## CHANGE REQUEST

⌘ **04.08 CR** ⌘ rev **-** ⌘ Current version: **7.10.0** ⌘

<b>Title:</b>	⌘ Modification to MS's MM states to enable LCS signalling on RR layer		
<b>Source:</b>	⌘ Nokia		
<b>Work item code:</b>	⌘ LCS	<b>Date:</b>	⌘ 07.03.2001
<b>Category:</b>	⌘ <b>F</b>	<b>Release:</b>	⌘ R98
	Use <u>one</u> of the following categories: <b>F</b> (essential correction) <b>A</b> (corresponds to a correction in an earlier release) <b>B</b> (Addition of feature), <b>C</b> (Functional modification of feature) <b>D</b> (Editorial modification)		Use <u>one</u> of the following releases: <b>2</b> (GSM Phase 2) <b>R96</b> (Release 1996) <b>R97</b> (Release 1997) <b>R98</b> (Release 1998) <b>R99</b> (Release 1999) <b>REL-4</b> (Release 4) <b>REL-5</b> (Release 5)
	Detailed explanations of the above categories can be found in 3GPP TR 21.900.

Figure 4.1a / GSM 04.08: Overview mobility management protocol / MS Side

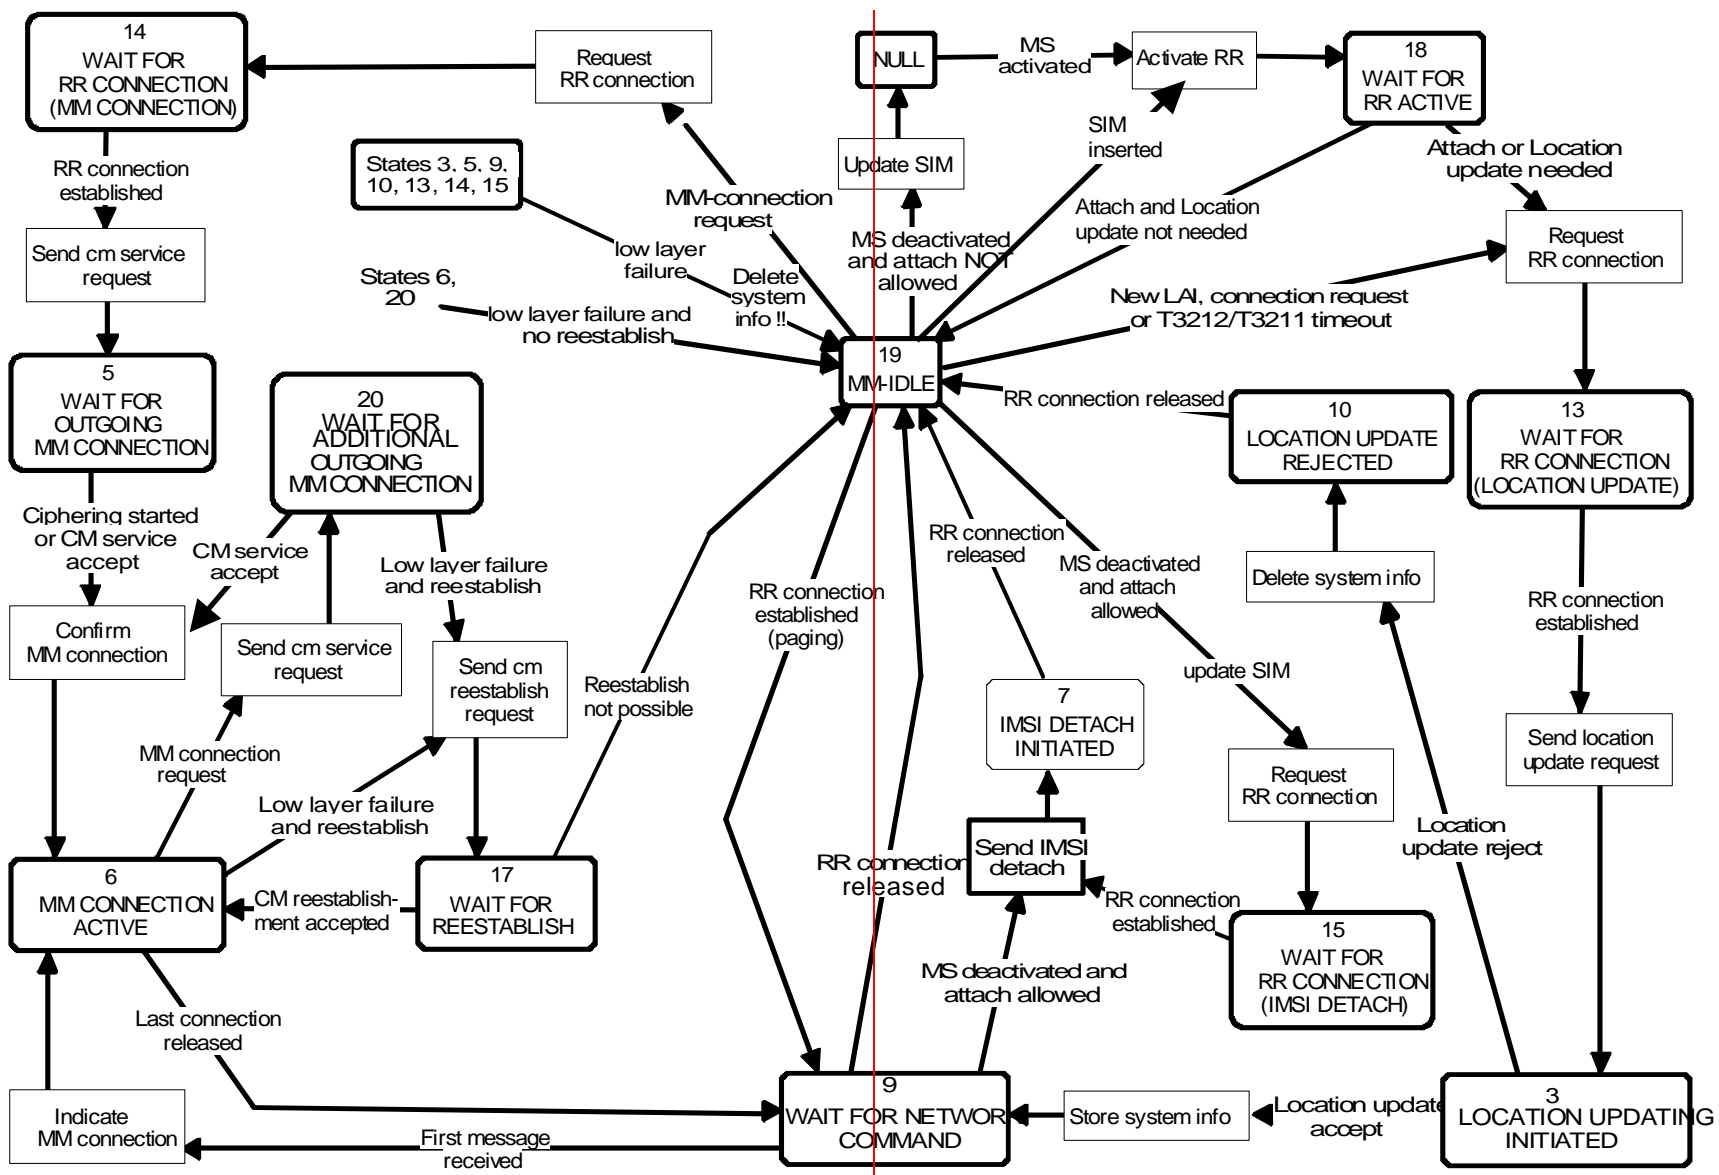
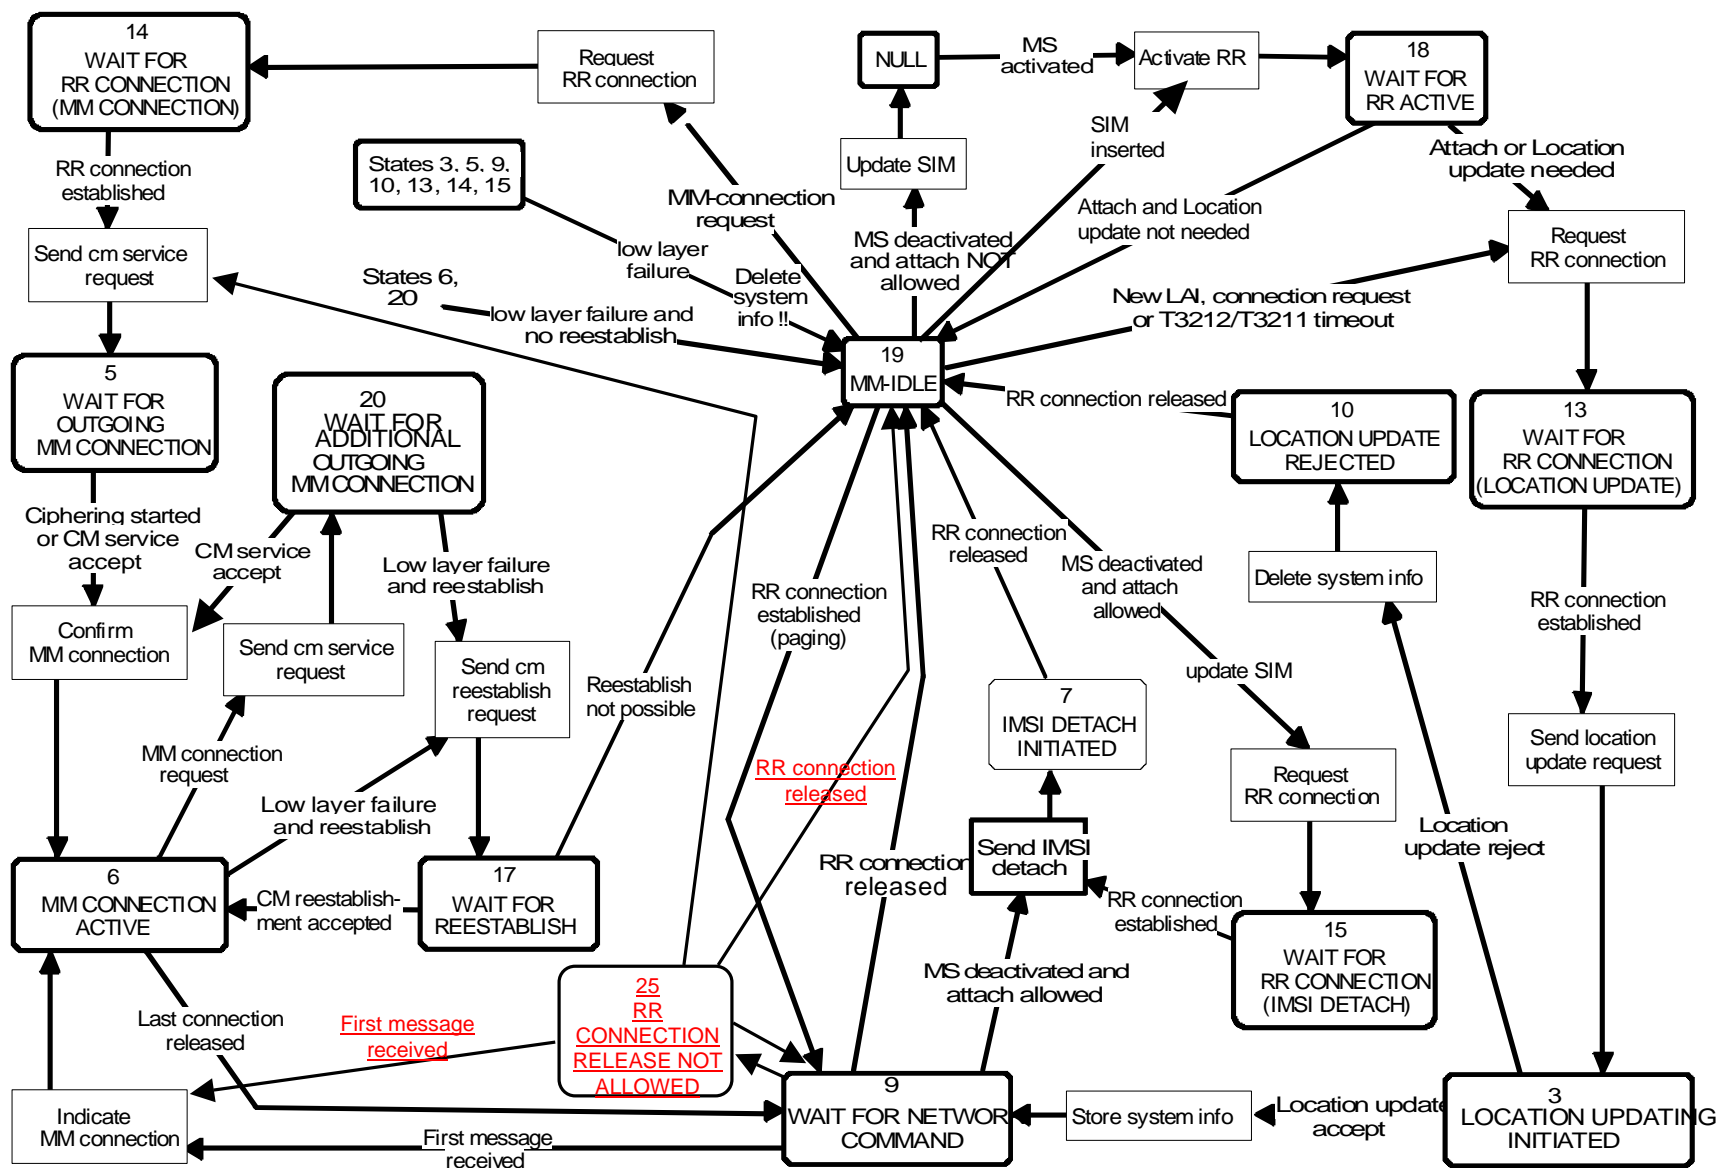
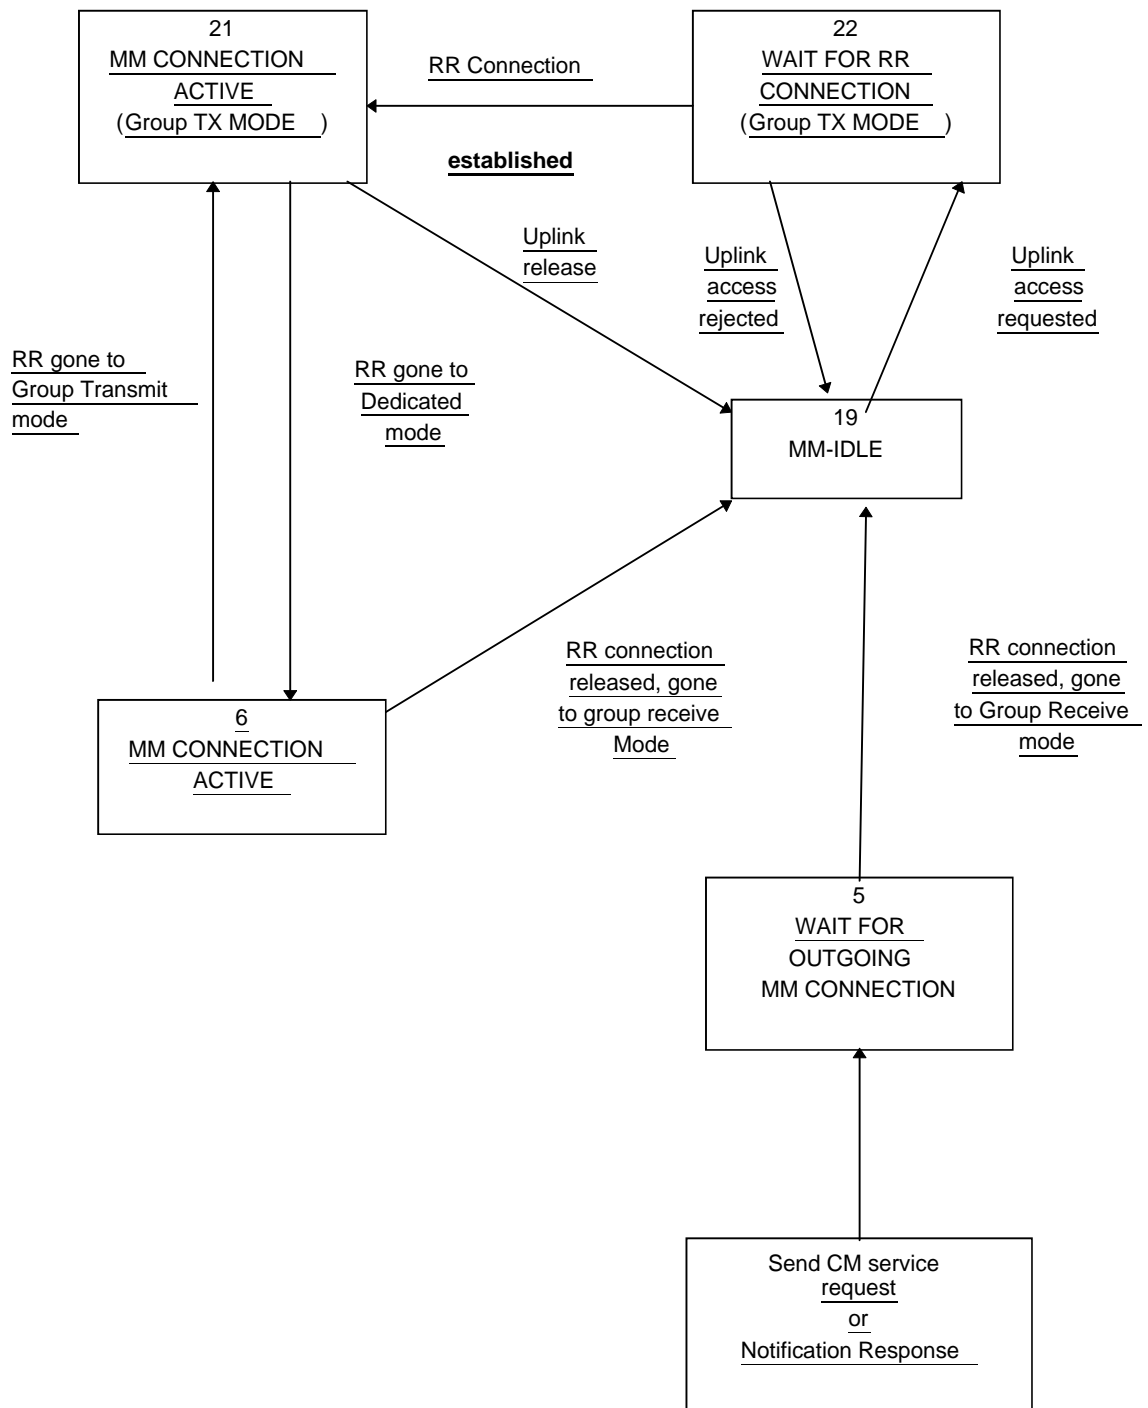
<b>Reason for change:</b>	⌘ LCS communication occurs in RR layer. For MT-LR/NI-LR case the MM layer is not active (from MS point of view) after authentication which causes that RR connection will be closed even if RR is needed for LCS signalling. The connection is closed by MS via T3240 timer within 10 seconds after last MM interaction. The LCS signalling may take longer than 10 seconds. This correction enables to stop T3240 timer and transit to a new MM state when RR layer sends indication to MM layer using RR-No-Abort-Ind (no abort) RR-SAP service primitive. The return to the normal MM operation occurs when RR-No-Abort-Ind (abort allowed) RR-SAP service primitive is received from RR layer. A new timer T32xx is added to guard the new MM state. This change together with CR to 04.07 (addition of RR-No-Abort-Ind primitive at RR-SAP in MS side) will correct the problem.
<b>Summary of change:</b>	⌘ The definition of a new MM state RR CONNECTION RELEASE NOT ALLOWED is added and the state transitions to/from the new state are defined. A new timer T32xx is defined.

**Additions to Figure 4.1.a/GSM 04.08**

#### 25. RR CONNECTION RELEASE NOT ALLOWED

(Only applicable for MSs supporting LCS) There is no MM procedure running but RR connection exists. The timer T32xx is running.
